# REGIONAL REVIEW NOTIFICATION

**ARC REVIEW CODE:** R704271

**Name of Proposal:** Swift Creek

Preliminary Report:	April 27, 2007	<b>DEVELOPMENT OF REGIONAL IMPACT REVIEW REPORT</b>	Project:	Swift Creek #1336
Final Report Due:	May 27, 2007		Comments Due By:	May 11, 2007

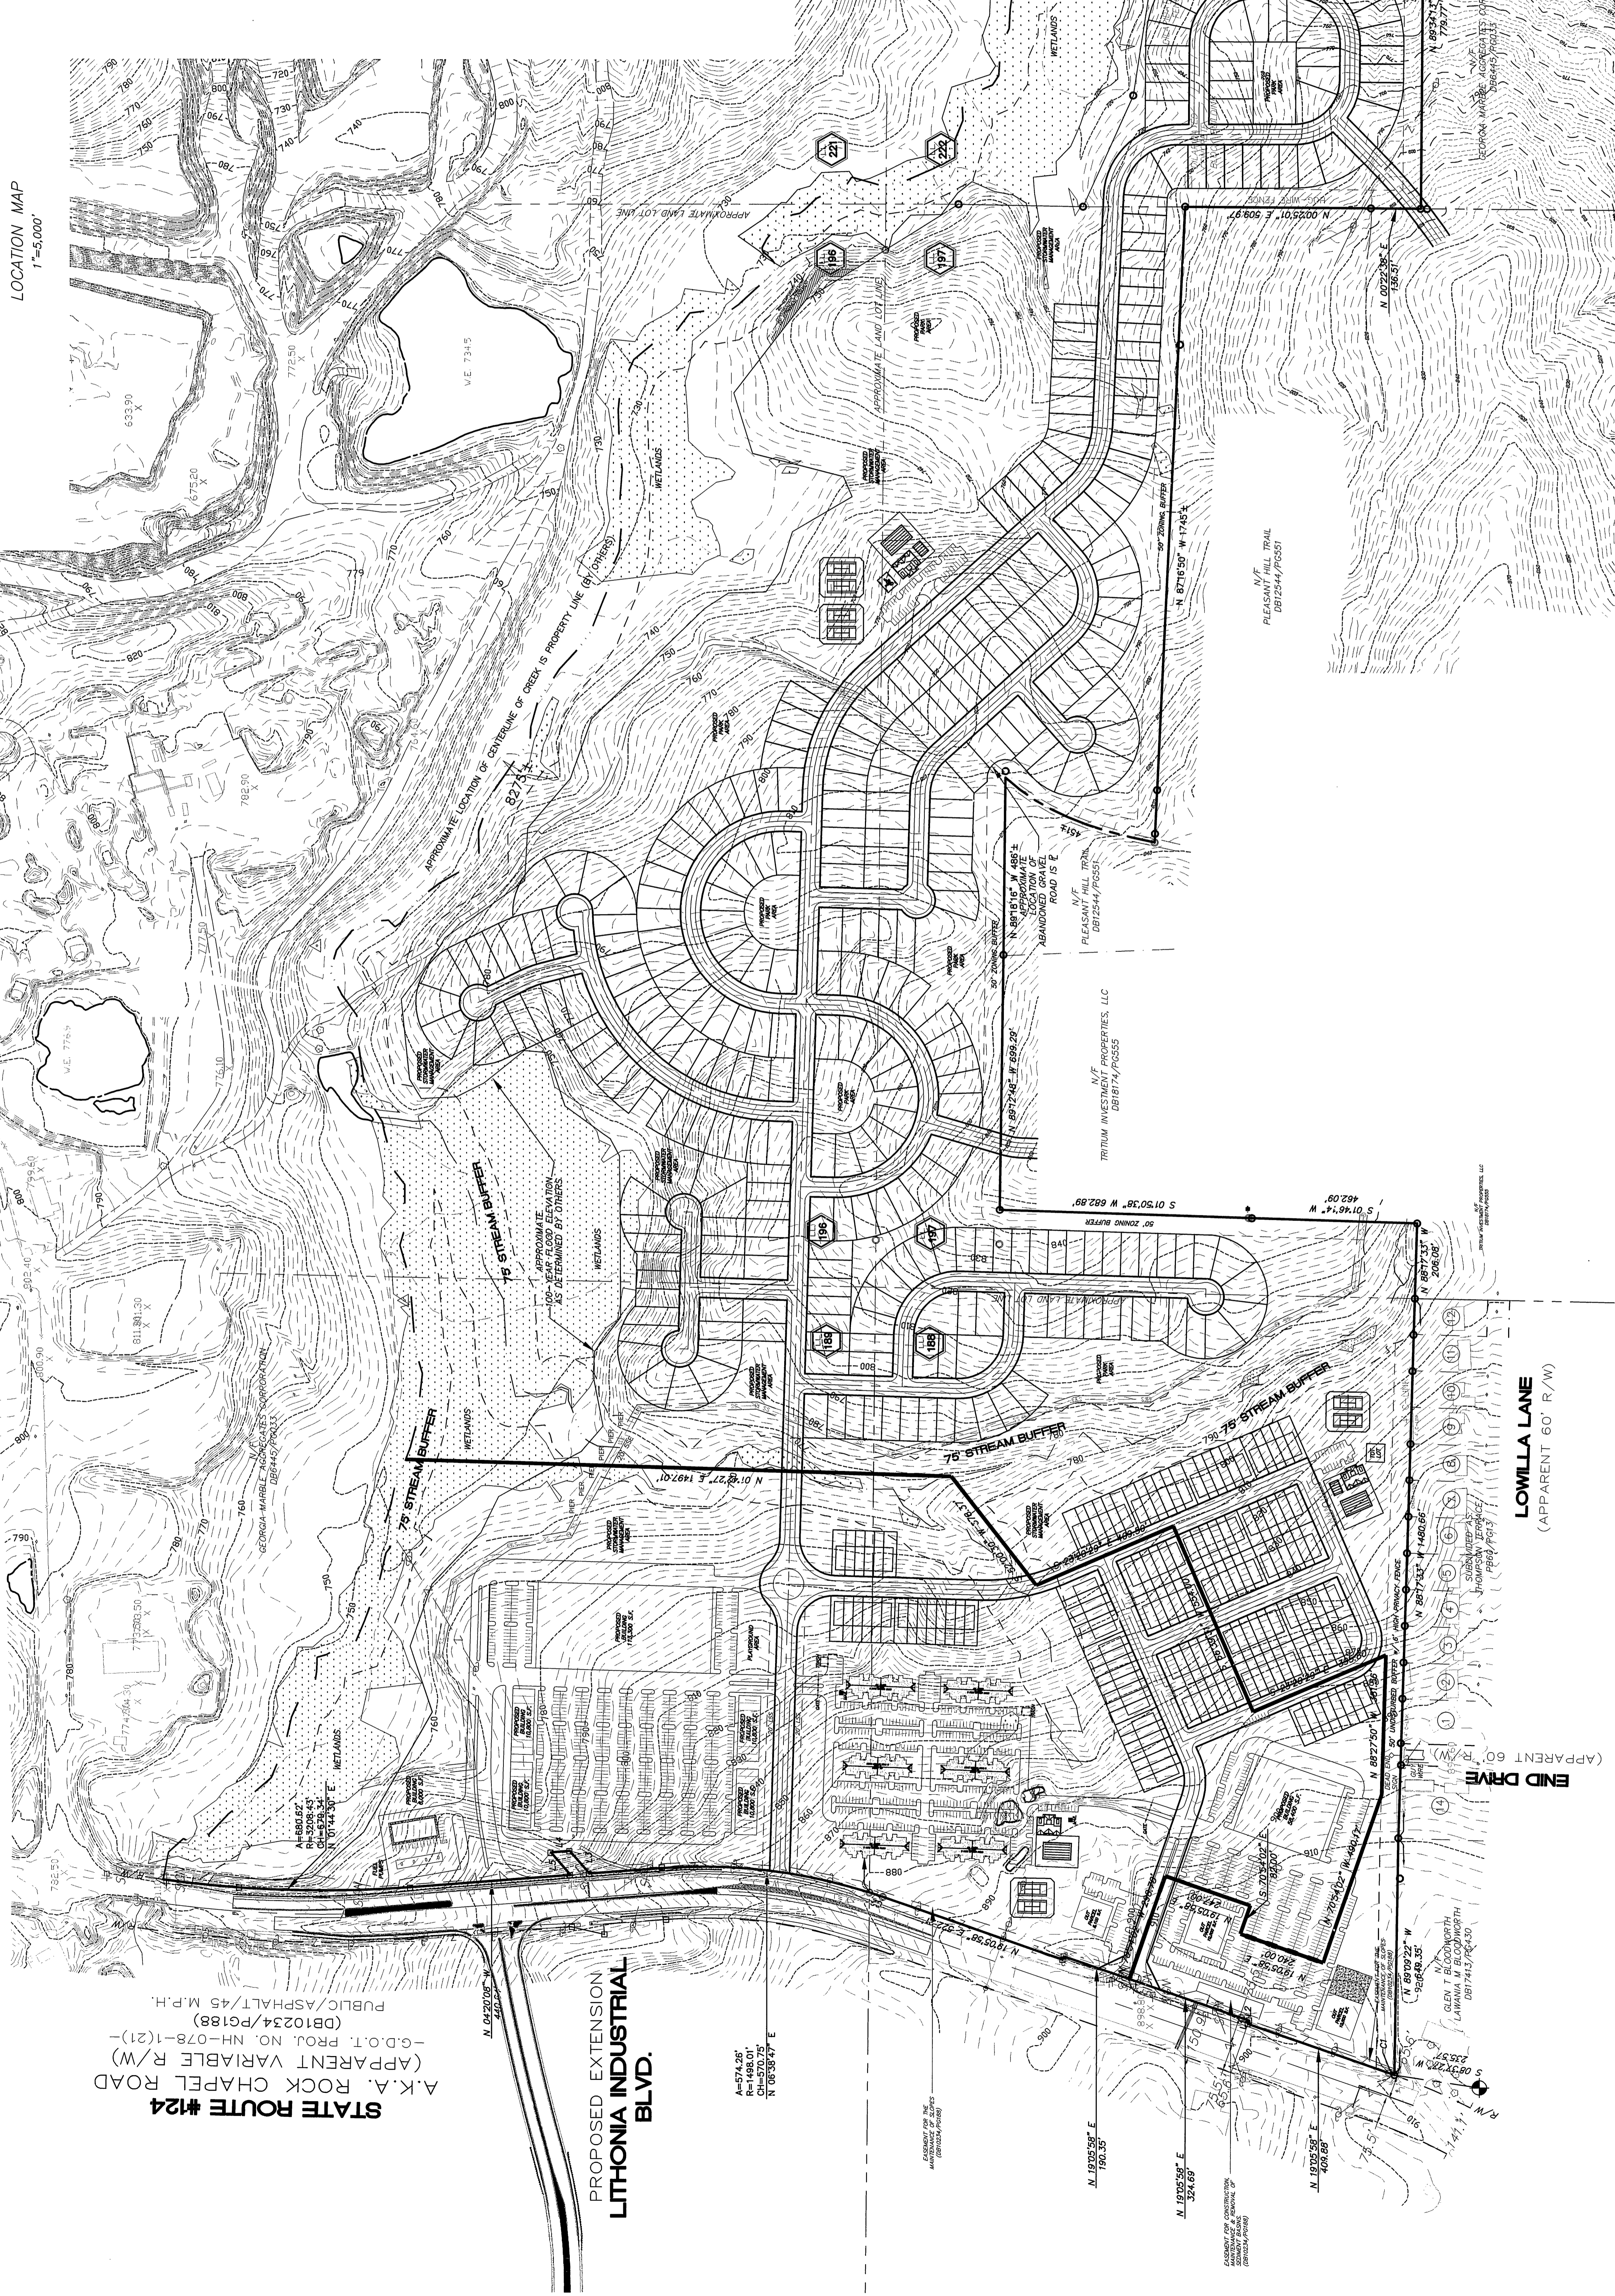
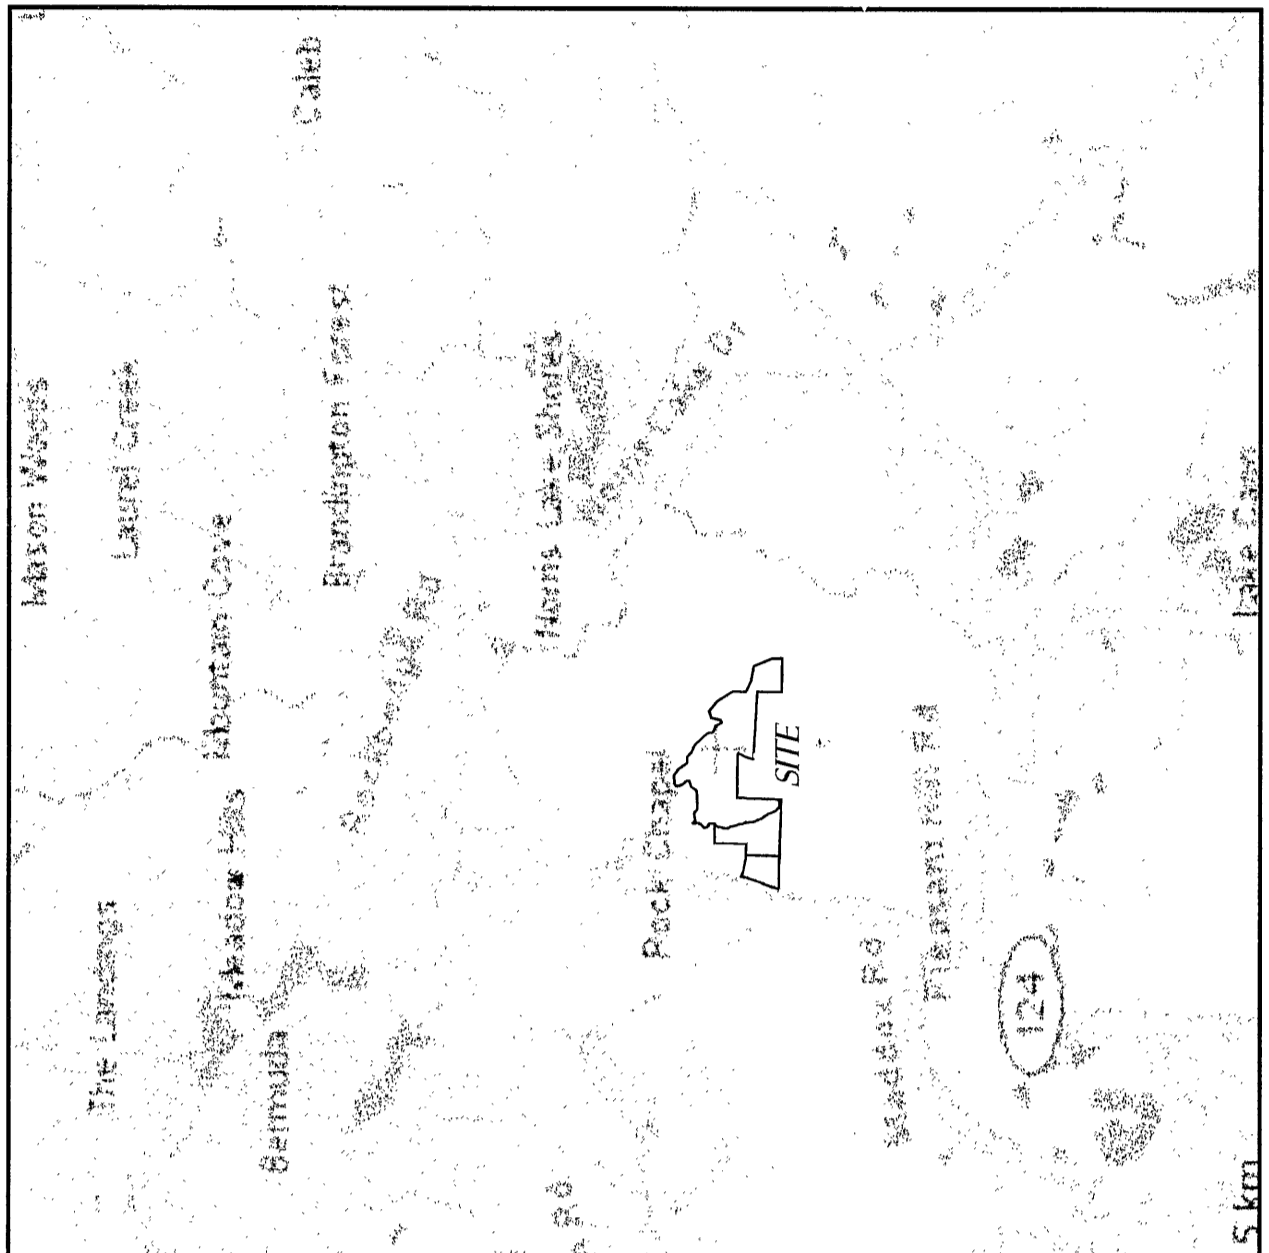
The proposed site plan should be revised into reflect better incorporation of the mix of uses and encourage alternative modes of transportation within the development. Revisions should include creating a true main street and pedestrian oriented entrance into the development along the main entrance. This includes the retail buildings to the north of the road to be oriented to the street with parking behind (as the site plan currently indicates) and the apartment buildings on the south side of the road to interact with the road in a similar manner as the north side. This implies creating stoop fronts on the apartment buildings, pulling the building to the road, and removing parking that abuts the road. The site plan indicates a gated apartment community that does not interact with the rest of the development. ARC staff discourages the use of gates and the traditional garden style apartment plans. Rather, incorporating creative design elements such as creating stoop fronts on the apartment buildings, pulling the building to the road, and addressing the street front of the main road into the development is encouraged. Also, the proposed playground area between the main driveway and the large commercial building is poorly suited. Finally, the uses within the site are segregated and do not relate well to one another. Because the development is located in a relatively rural area of the county, land conservation and preservation is important as the area begins to develop. It was strongly encouraged that the site plan reflects green space and seeks additional opportunities for the conservation of open space. Revisions to the site plan can reflect additional conservation and open space while providing a greater sense of community and interaction among the future residents. Residents should be able to walk or bike throughout the development through off road trails and sidewalks. The development, as shown on the submitted site plan, is not conducive to walking and biking within the development.

Direct pedestrian connections providing the shortest walking distance possible, including off road facilities, should be provided between all uses within the site. The developer is also encouraged to provide stub outs into the Tritum Investment and Pleasant Hill Trail properties immediately to the south of the proposed site as shown on the site plan.
